Subject: Installation of a pneumatic tailwheel in exchange for the tailskid.

Affected gliders: All K 7s.

Fig. 1

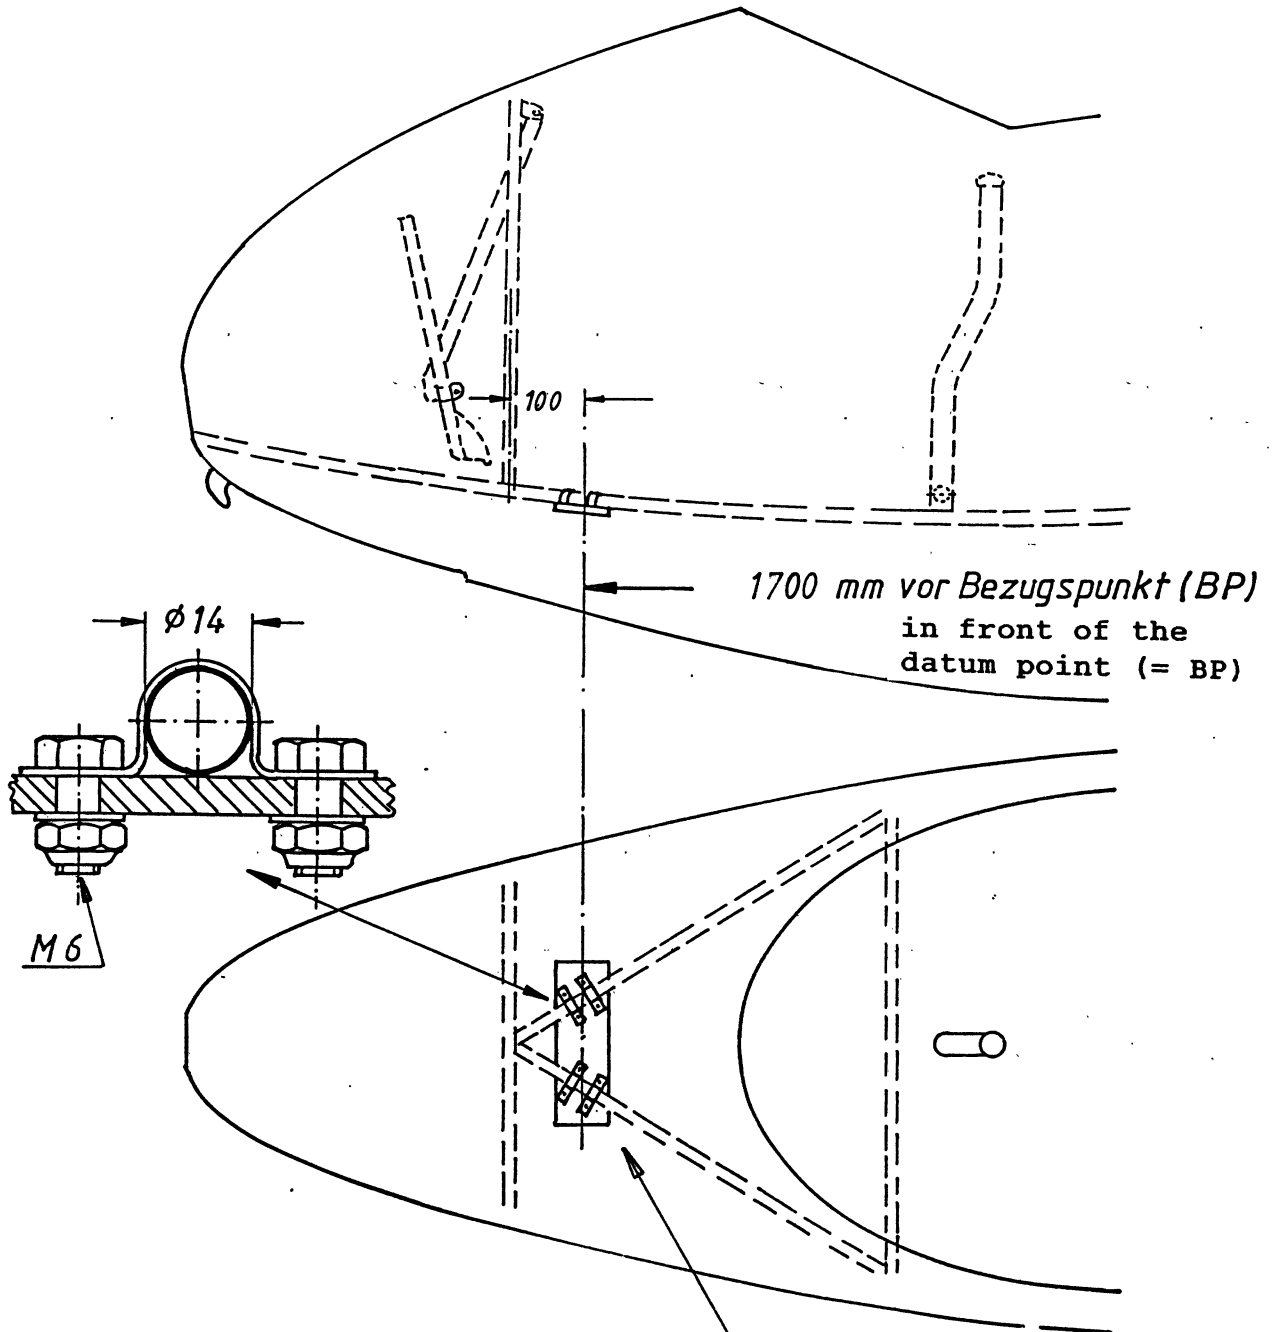
Action: According to drawing "Installation of pneumatic tailwheel" dated Feb.1, 1986, the fuselage is modified and the tailwheel installed. Depending on the new C.G. position a corresponding trim mass must be fixed in the fuselage nose below the front foot panel (see Fig.1).

Mass and C.G.: Owing to this modification the mass of the non-lift producing parts is increased by approx. 250 g and the C.G. is moved back by approx. 3 mm (0,12 in). Therefore, it is necessary to redetermine the mass and C.G. data. If the result of the C.G. weighing shows that the permissible C.G. range is exceeded, the short mass must be calculated and a corresponding trim weight must be fixed in the fuselage nose (see Fig.1).

According to the measured C.G. data the corresponding
trim mass must be fixed at the bracings below the foot panel!
